Austral Park Road Interchange and Heavy Vehicle Rest Area

Working group presentation 5 March 2012

HW1 NORTH KIAMA BYPASS
NUNGARRY REST AREA
SOUTHBOUND ACCELERATION LANE

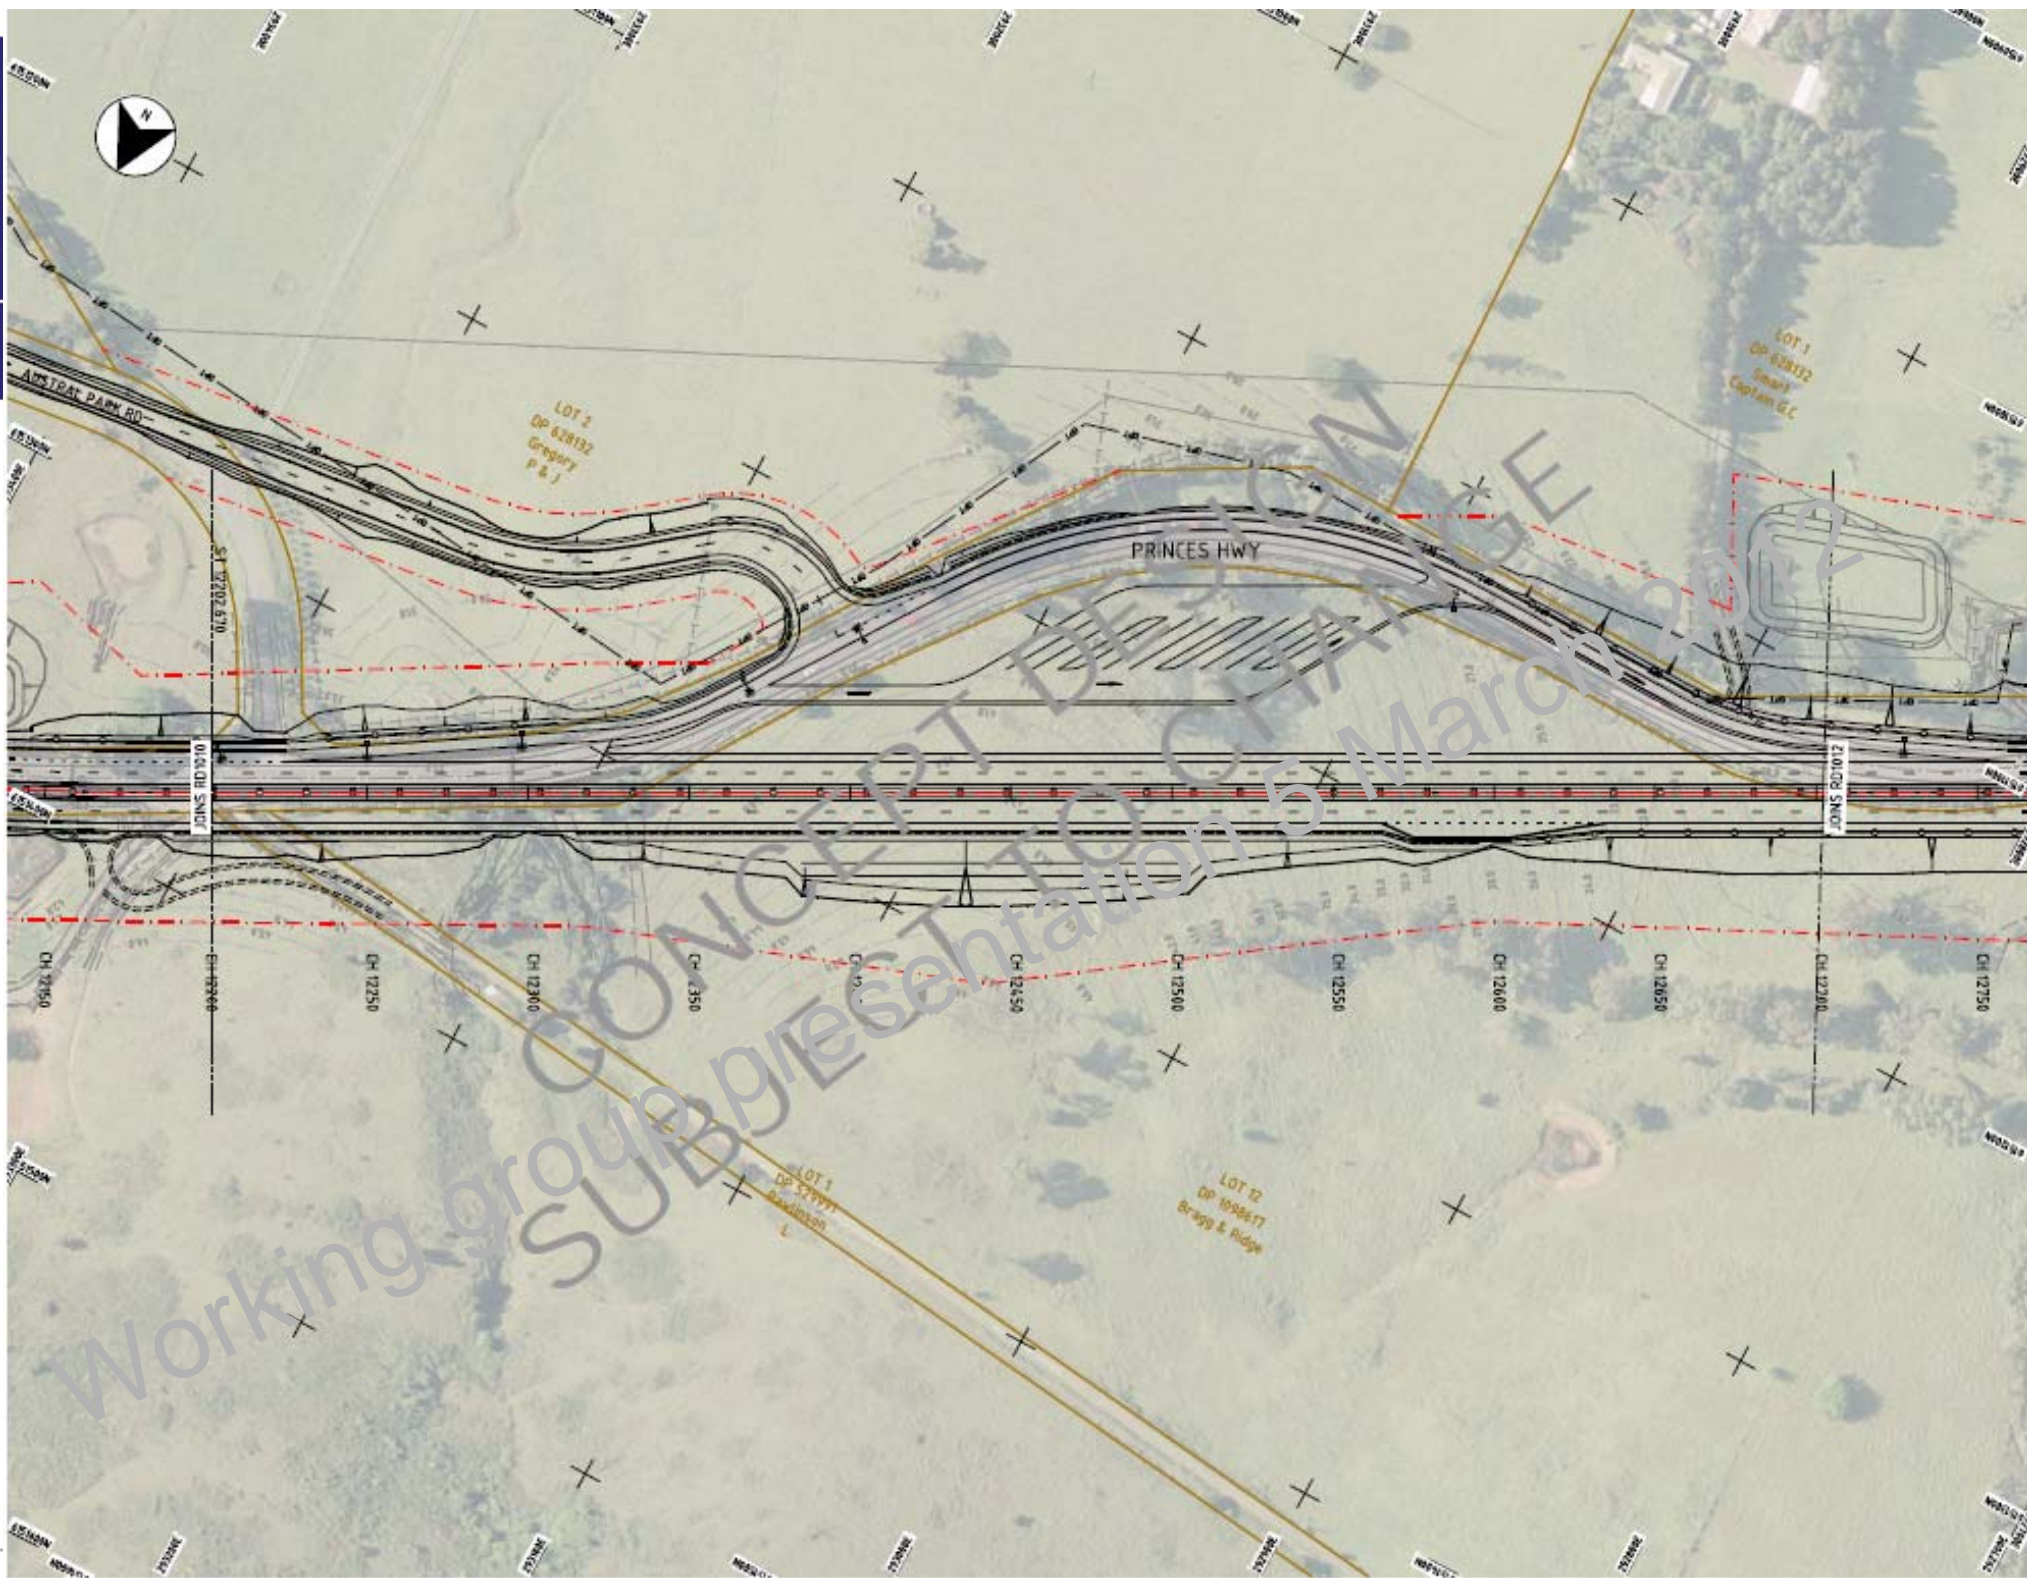
- Existing compliant site. However there is limited acceleration lane for HV on departure from site. An increase in capacity for HV is desirable.

- Construction of acceleration lane would require:
- extending major culvert (or raising headwall)
 - partial filling of water supply dam for western farm,
 - relocation of water quality and spill basin
 - relocation of stopping and emergency services u-turn bay
 - relocation of "Kiama" wall
 - relocation of sewer and water main to rest area
